## COUNCIL ASSESSMENT REPORT

<b>Panel Reference</b>	PPSSWC-372
<b>DA No.</b>	DA 294.1/2023 PAN-354293
<b>LGA</b>	Fairfield City Council
<b>Proposed Development</b>	Demolition of existing structures, Tree removal and the Construction of a 6-storey Residential Flat Building containing thirty – nine (39) dwellings over a basement car park containing 28 car spaces and associated landscaping and civil works.
<b>Street Address</b>	Three (3) lots consisting of: <ul style="list-style-type: none"> <li>▪ 15 Lupin Avenue, Fairfield East (Lot 1 in DP 1154467)</li> <li>▪ 17 Lupin Avenue, Fairfield East (Lot 185 in DP 15560)</li> <li>▪ 82 Belmore Street, Fairfield East (Lot 2 in DP 1154467)</li> </ul>
<b>Applicant</b>	BlueCHP
<b>Date of DA Lodgement</b>	26 <sup>th</sup> September 2023
<b>Total number of Submissions</b>	27 total submissions (inclusive of petition)
<b>Number of Unique Objections</b>	17 unique objections
<b>Recommendation</b>	Deferral

<b>Report Prepared By</b>	Liam Hawke, Coordinator Development Planning
<b>Report Date</b>	24 March 2025

Figure 6. Proposed Typical Level 4 and 5 Floor Plan for Residential Flat Building.

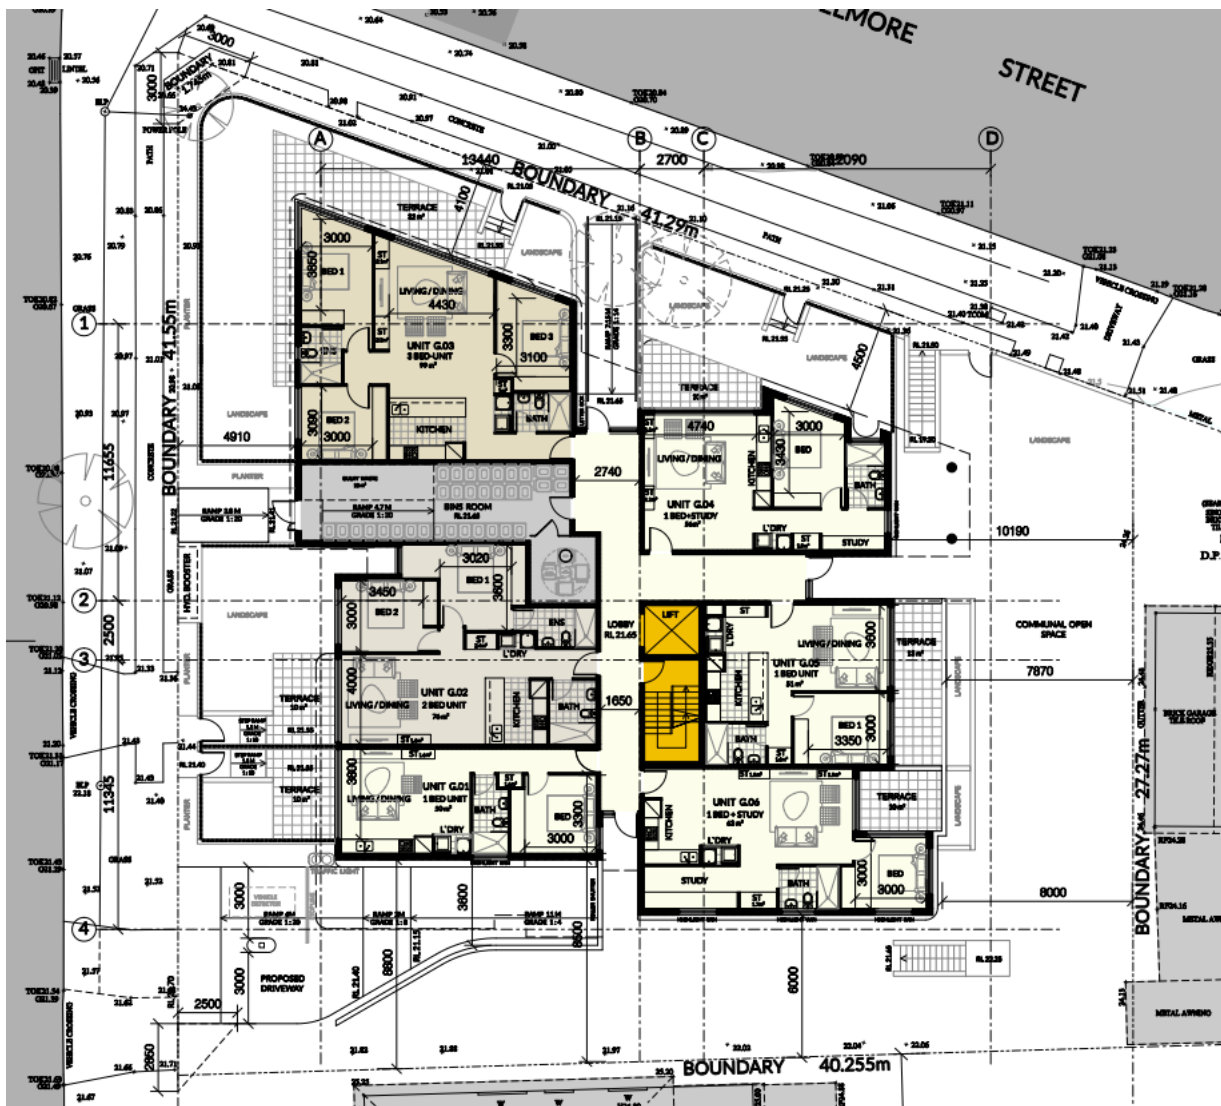
- Building setbacks to the southern boundary do not comply as follows:
  - o For Levels 4 and 5, a 9m minimum setback is required for habitable rooms. Unit 4.06 and 5.06 have a bedroom with a window that is setback 7.29m along the southern boundary. It is noted that the 2 subject windows are highlight windows which may assist in visual privacy, however, the purpose of the setback is also required to provide acoustic privacy as well. The 2 subject windows cannot be removed as they are required in order to provide the required 60% of dwellings for natural ventilated unit requirement.

- Building setbacks to the southern boundary do not comply as follows:
  - o For Levels 4 and 5, a 9m minimum setback is required for habitable rooms. Unit 4.06 and 5.06 have a bedroom with a window that is setback 7.29m along the southern boundary. It is noted that the 2 subject windows are highlight windows which may assist in visual privacy, however, the purpose of the setback is also required to provide acoustic privacy as well. The 2 subject windows cannot be removed as they are required in order to provide the required 60% natural ventilated unit requirement.

Resolution: Units 4.06 and 5.06 should be redesigned to allow for natural ventilation and remove openings directly facing the southern boundary. The COS on the rooftop should be setback 9m from the southern boundary. Additional privacy features should be incorporated into the design that addresses internal privacy issues.

Figure 9. Proposed West Elevation facing Lupin Avenue.

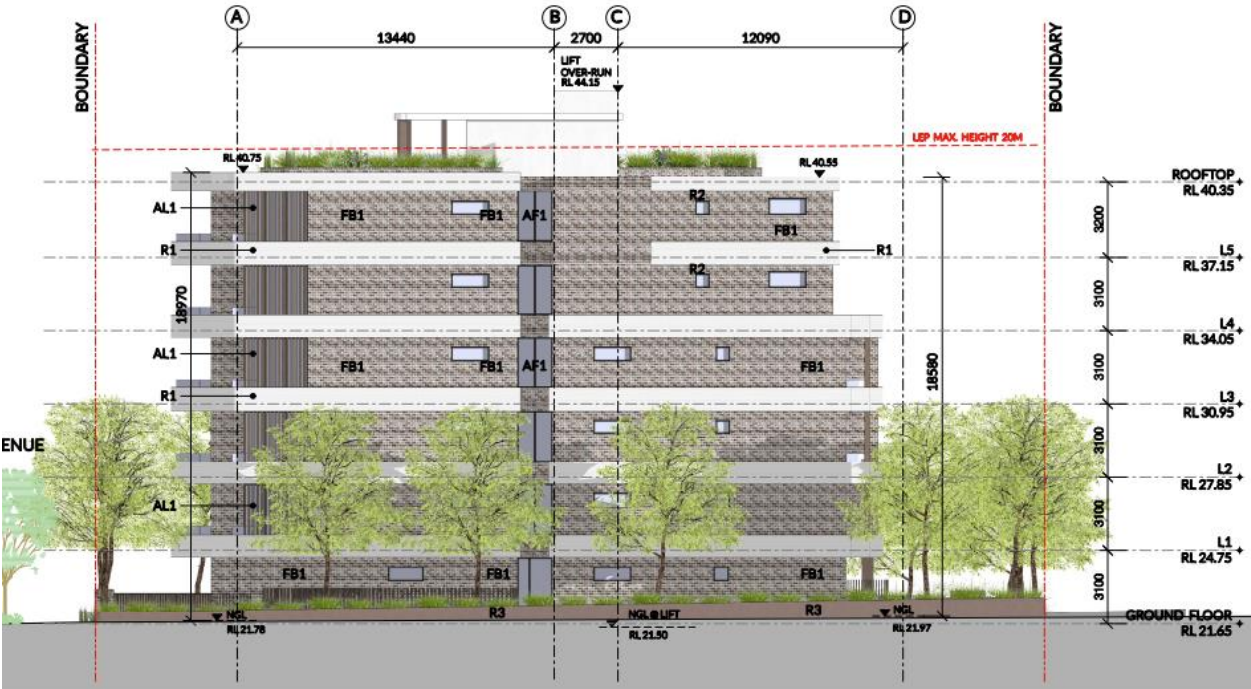
Clause 4.3 of the Fairfield Local Environmental Plan 2013 allows for a maximum building height of up to 20m at the subject site. The application proposes a height of up to 22.65m, and therefore exceeds the development standard by 2.65m. This equates to a variation of 13.25%. The proposed variation is illustrated in the figure below.
